Informazione Tecnica **466000140**
Modifica cablaggi GDX41NFH rev.000

Modifica del sistema di connessione dei cablaggi

Modelli interessati: - **GDX41NFH** -

settimana di inizio in produzione: - 2007/29-

Comparto freezer: dettagli (nuova versione)

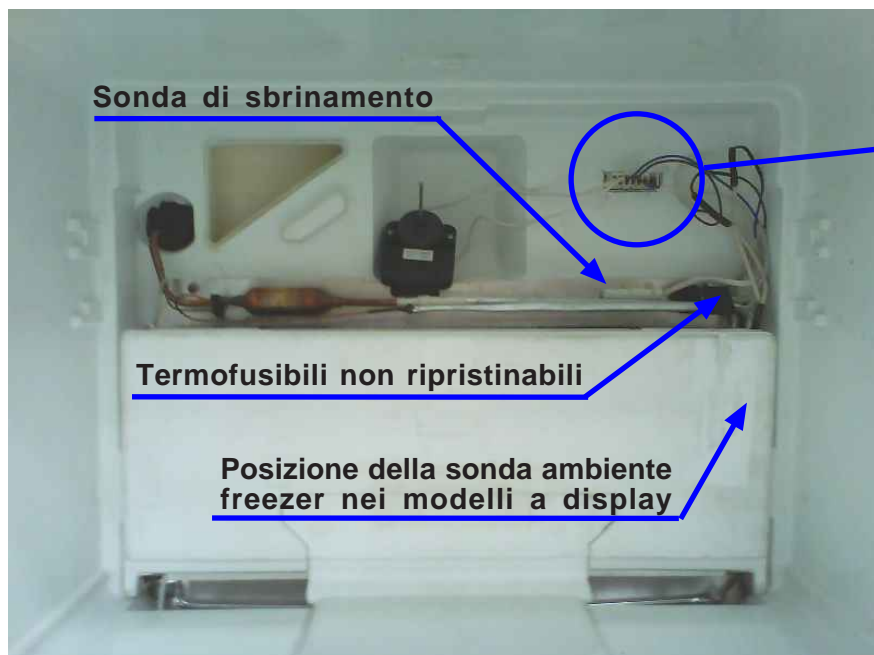
La modifica prevede nuovi cablaggi interamente schiumati, l'introduzione di un nuovo blocchetto di connessione dei cablaggi interni e la fine dell'uso per la scatola di connessione al lato posteriore dell'apparecchio: con il nuovo blocchetto vengono anche utilizzati nuovi connettori per i fili del motoventilatore, delle sonde, della resistenza e dei termofusibili che di conseguenza assumono un nuovo codice.

Nuovo tappo utilizzato nel diffusore del comparto freezer

La rimozione del tappo consente il collegamento dei cavi del motoventilatore in caso di sostituzione e l'ispezione del connettore interno

GDX41NFH versione display (con damper) GDX41NFH versione 3 led (con damper)

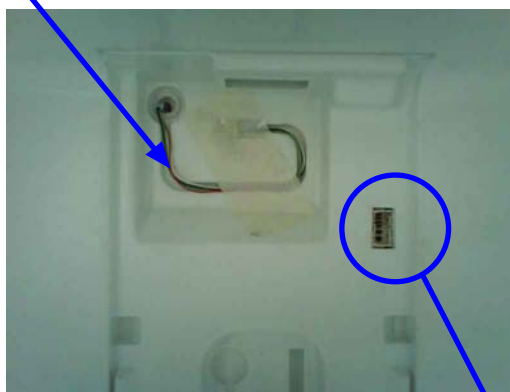
(Regolazione separata frigo freezer) come attuale ma viene tolta la scheda morsettiera esterna ed i cablaggi sono interamente schiumati: nuova batteria

Comparto frigo: dettagli (nuova versione)

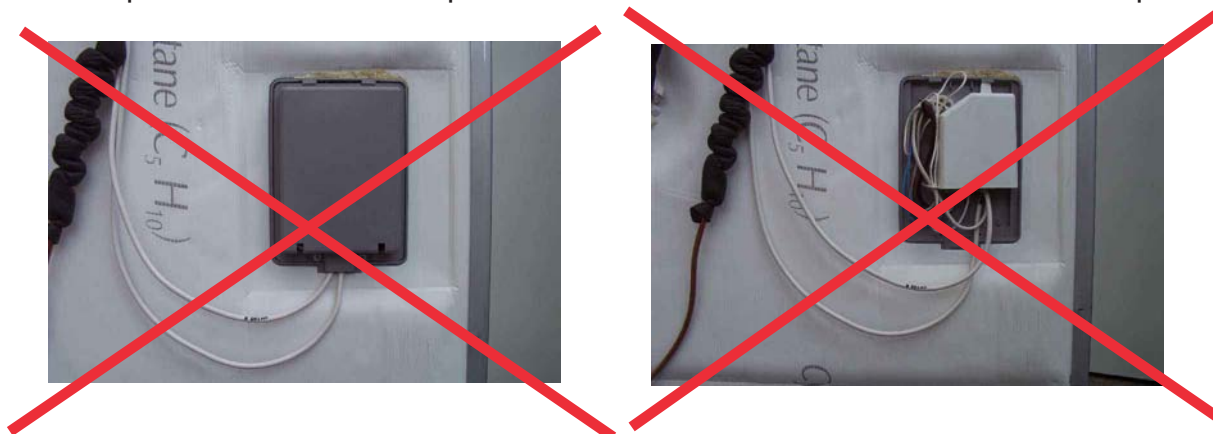
Area del diffusore al comparto frigo: zona non a vista

Cablaggio Damper schiumato:
il cablaggio è presente solo
nelle versioni display e 3 led.
(la versione 5 led prevede invece
un diffusore in polistirolo senza damper)

**Nuovo blocchetto schiumato
per cablaggio lampada**

Freezer compartment: details (new version)

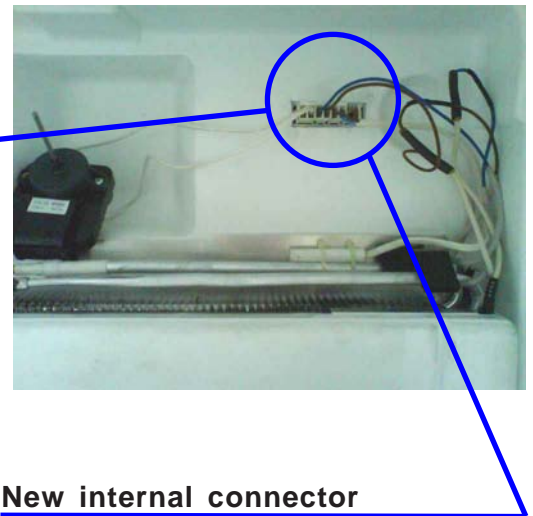
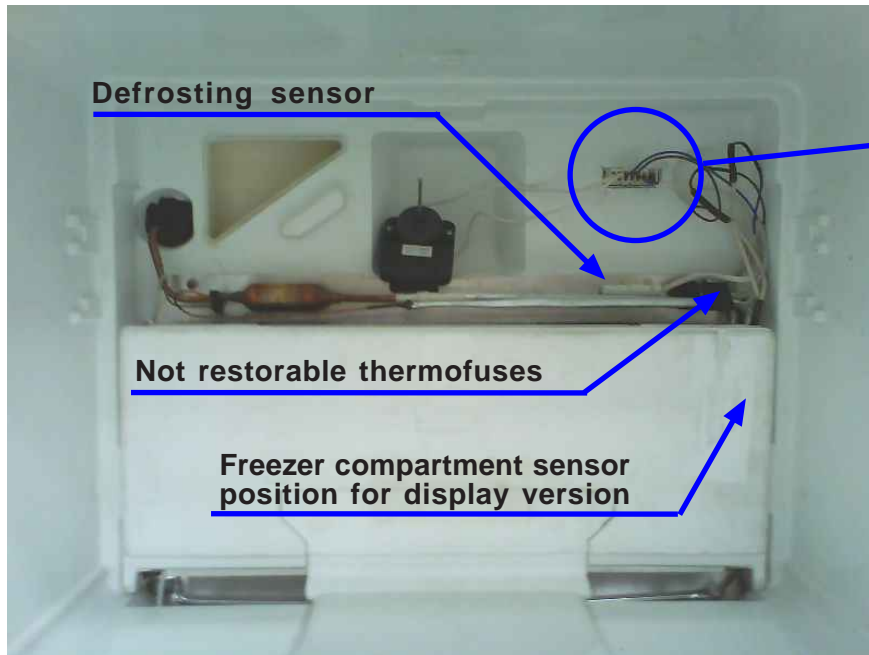
Modification provides new wiring completely integrated in the foam, use of a new internal connector for the wires and the end of use for the connection box at the back side of the appliance: with the new internal connector are changed also new connectors for the wires of the following parts: motor fan, sensors, heating element and thermofuses to which parts, consequently, will be assigned a new code.

New cover used inside the diffuser at the freezer compartment

View without cover:
removing the cover allows to connect the wires of the motor fan and to inspect the internal connector

Fridge compartment: details (new version)

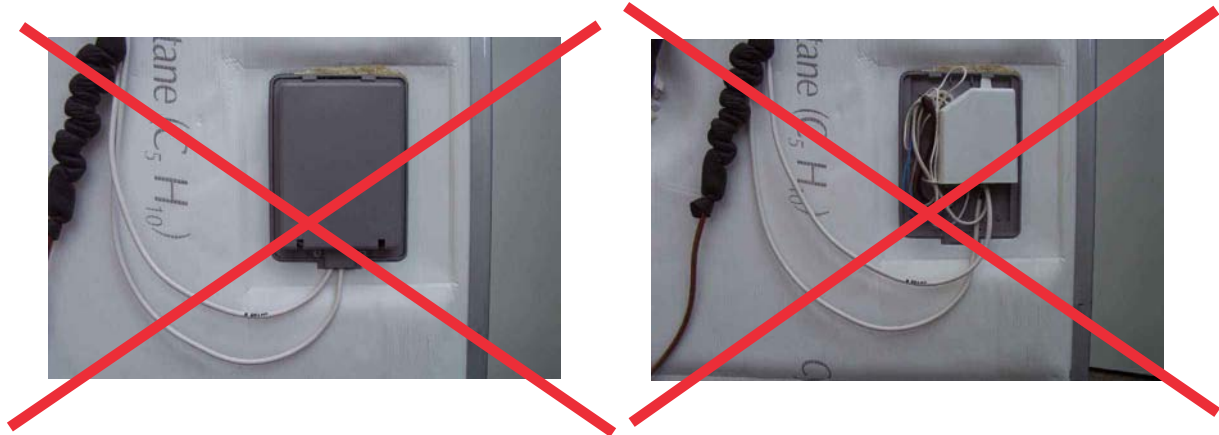
Fridge compartment diffuser area: not visible area

Foam integrated Wiring for the Damper:
Wiring is available only in the versions "display" and "3 led".
(the new version 5 led provides instead a diffuser in polystyrene without damper)

New wiring integrated in the foam for the lamp connection
